LETTER OF SUBMITTAL
KFM Skyway Project # 04-012024

Subject: USI - Documents Clearing USI KFM NCR #64 (METS 50)

PROJECT: SFOBB Skyway Structure

Subject: KFM/USI NCR No. 50: Deviating from Approved Fabrication Procedures (Fabrication of web plates pa49 and pa50)

Weld distortion due to welding rib Pg 49

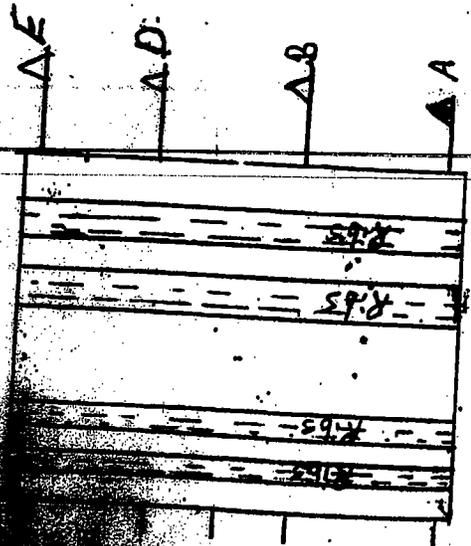
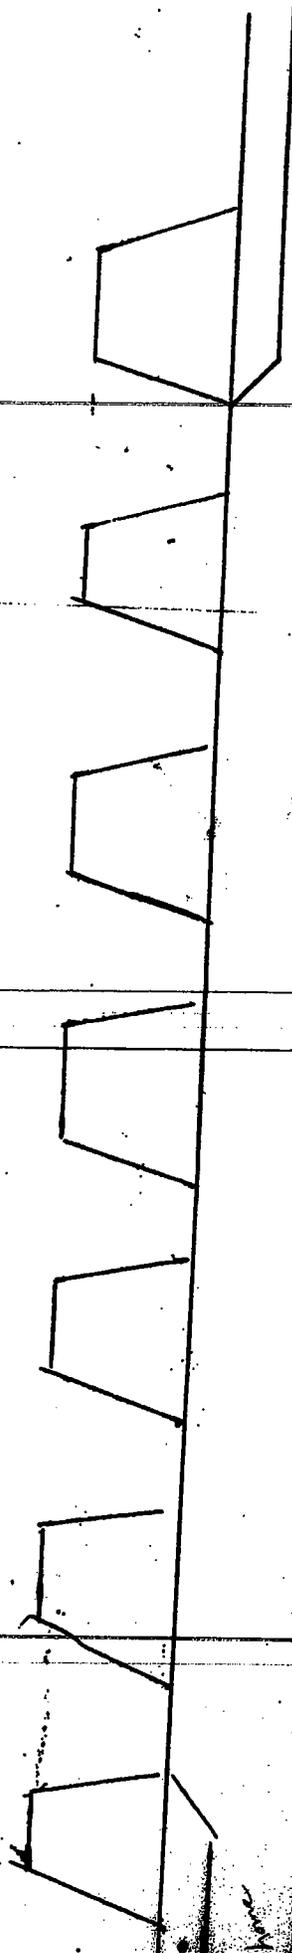
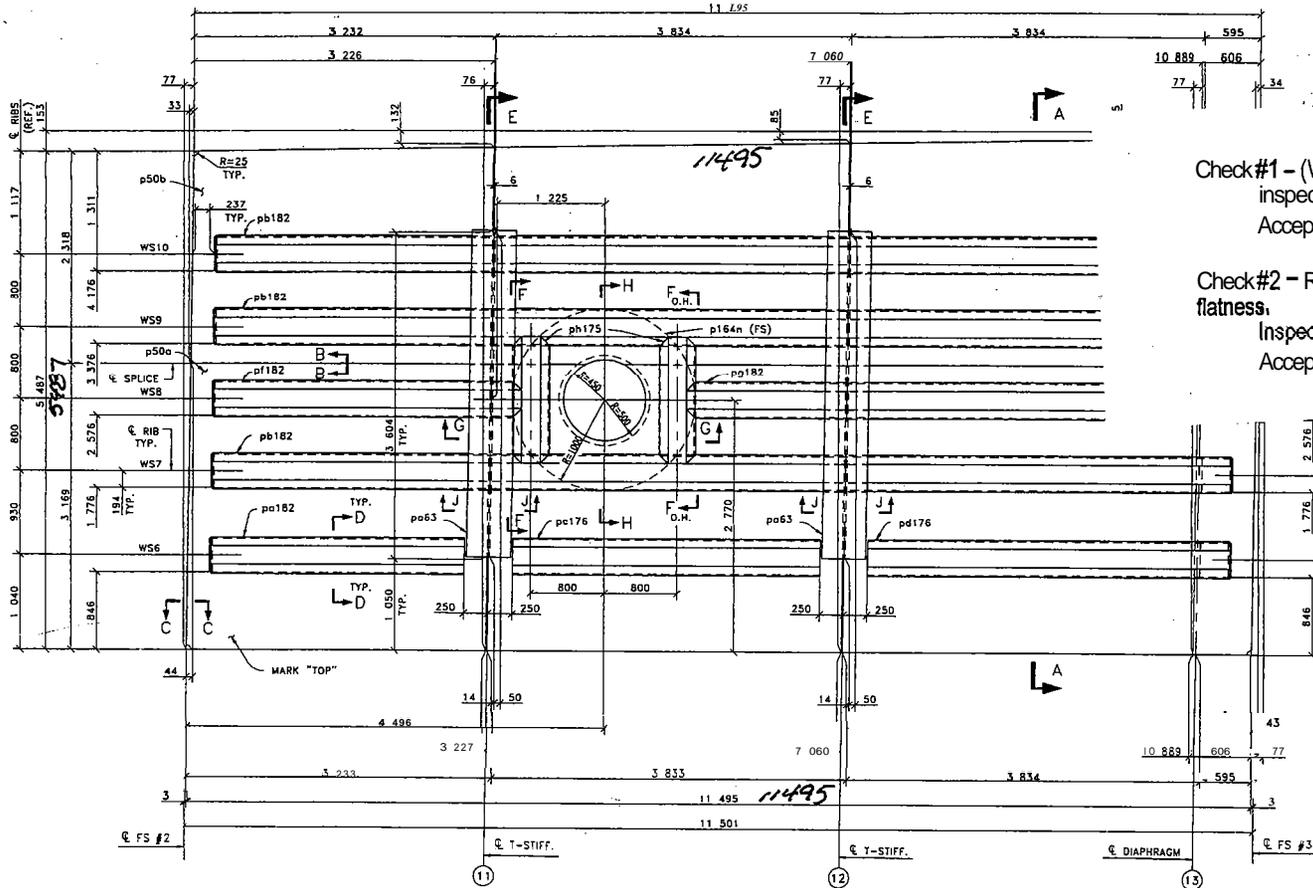
Step 1 - Details of Incident:
web Pa 49 has weld distortion. (see attached sketch)

Step 2 - Corrective Action: Engineer approval required: yes no
THE PLANT MANAGER HAS REVIEWED HIS PROBLEM AND FINDS THAT THE DISTORTION WILL NO LONGER BE OUT OF TOLERANCE WHEN THE WELD IS FIT TO THE SPEC.

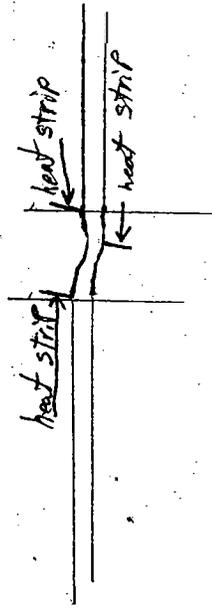
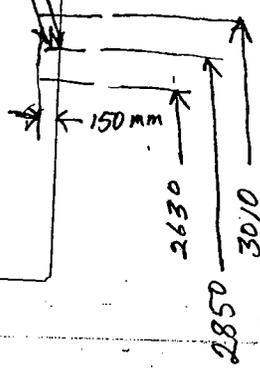
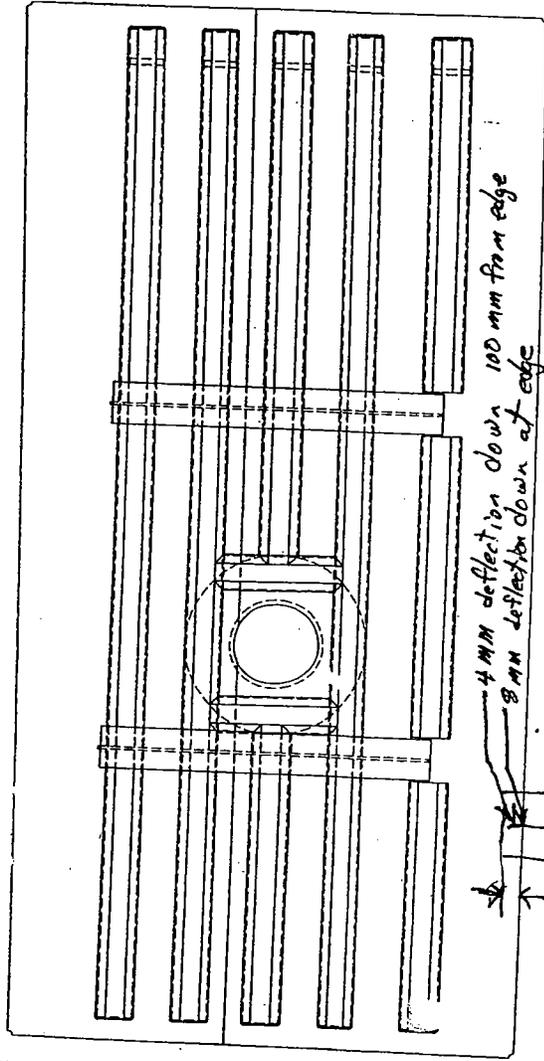
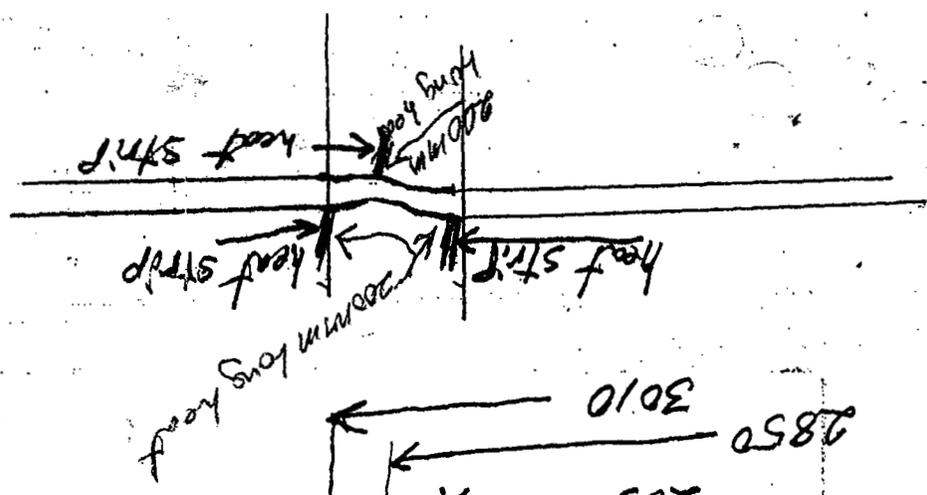
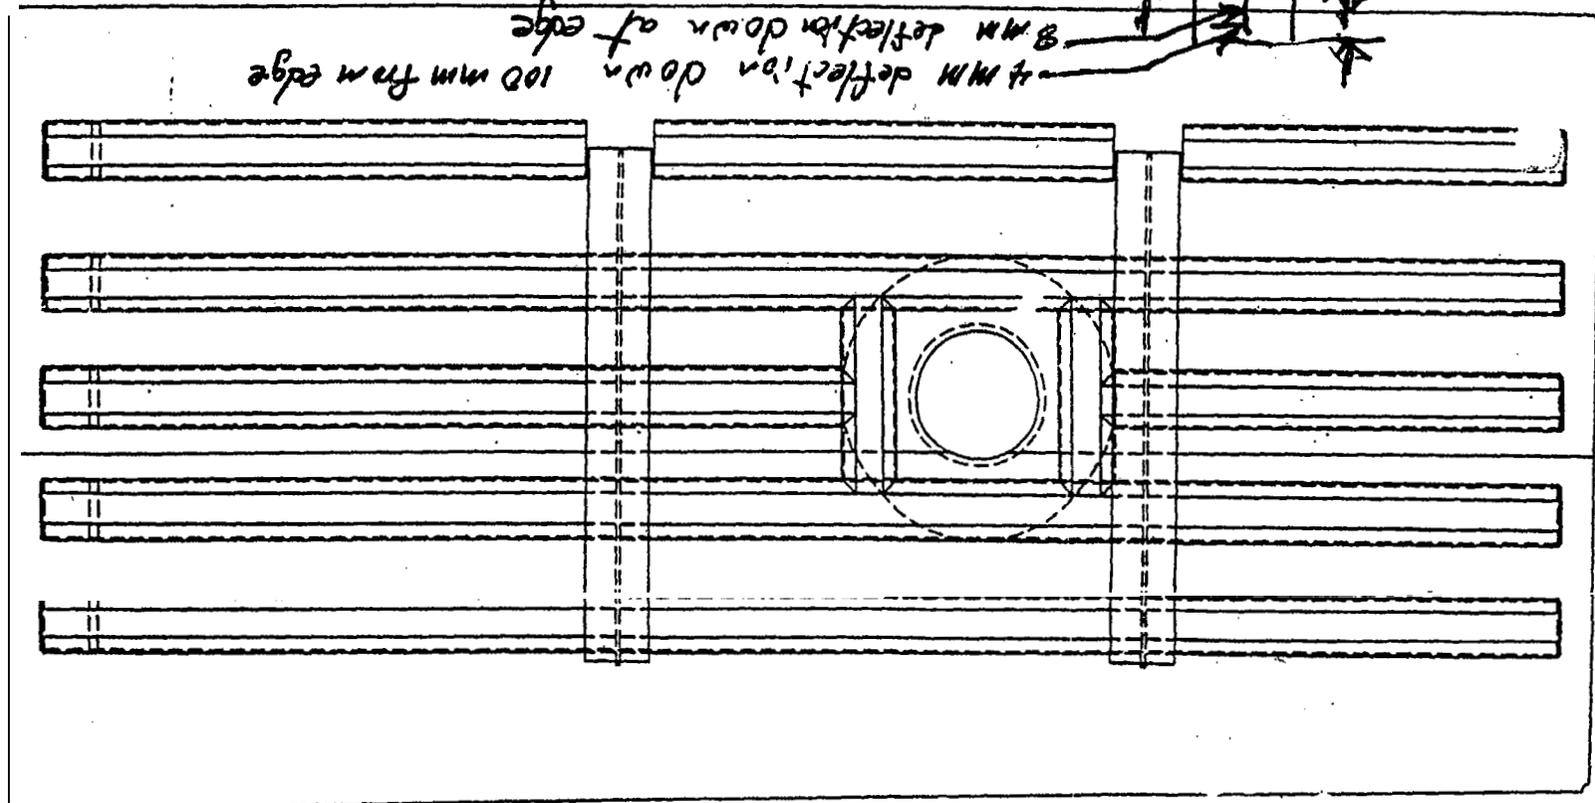
Step 1 - Details of Incident:
Web Pl. Pa50 There is a dent 380mm long by 150mm deep in top of web. 8mm max distortion. Per attached drg.

The Engineer has reviewed KFM-SUB-002968R00: USI Heat Straightening Request 04-34 regarding the request to repair web plate, pa50. The damaged web plate, pa50 is hereby rejected in accordance with Section 55-1.04 of the Standard Specifications until such time **as** the Contractor can demonstrate it **conforms** to the contract requirements. The Contractor should nondestructively test the web plate along the axes of bending in order to **confirm** additional damage has not occurred. After performing the nondestructive testing, the State QA inspector will observe the applications of heat in accordance with the subject submittal. The Engineer has concerns regarding the Contractor's ability to adequately handle material **as** noted in **State Letter** No. 5815.

Responsible Department: _____ Department Supervisor _____
Step 2 - Corrective Action: Engineer approval required: yes no
Restrain affected area + apply 3~~7~~ strip heats as per attached sketch.
Comp. 10-12-04

One line heat was applied to the bent area on pa 50 and brought it into tolerance. 100% of the heated area was Magnetic Particle Tested and had passing results.

1500 mm long area
 flat within 2 mm after heat

PA50 GIRDER 3A

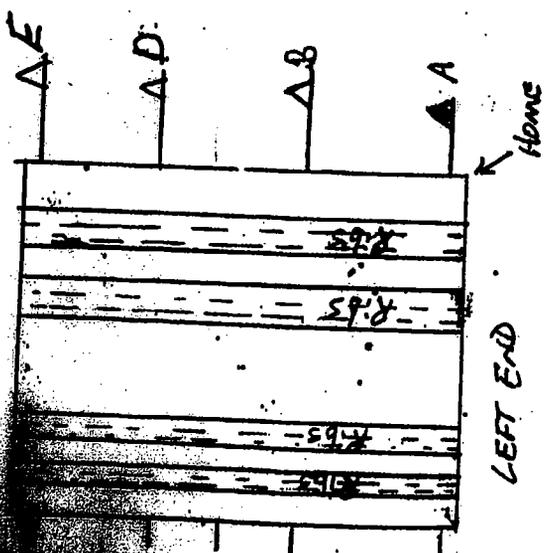
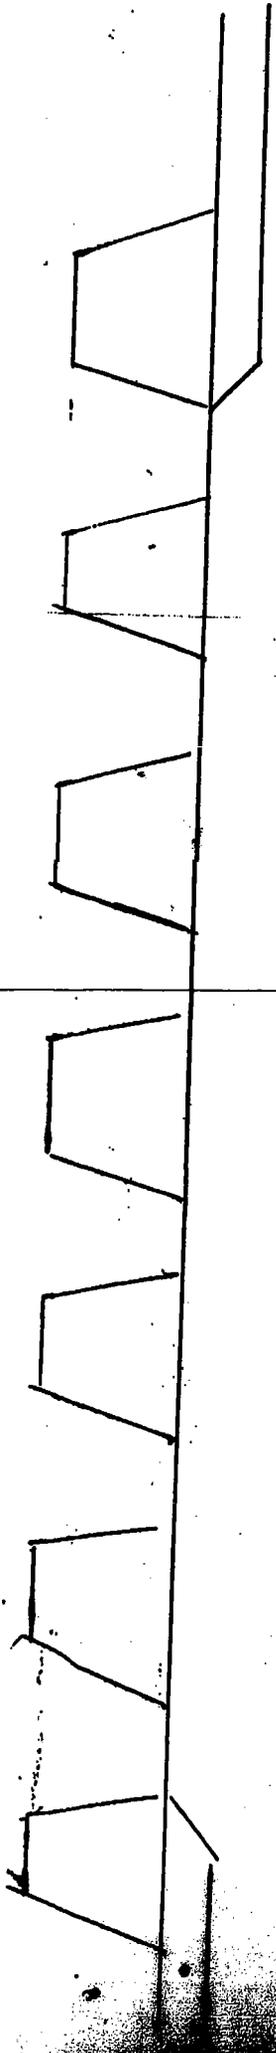
Step 1 - Details of Incident:
WEB PLATE ASSEMBLY PASD ON GIRDER 3A HAS
WELD 2" TYP - SEE ATTACHED SKETCH

Step 2 - Corrective Action: Engineer approval required: yes no
PLANT MANAGER HAS REVIEWED THIS PROBLEM
AND CONCLUDES THAT THE DISTORTION WILL NOT
BE OUT OF TOLERANCE WHEN THE WEB IS
FIT TO THE SOFFIT.
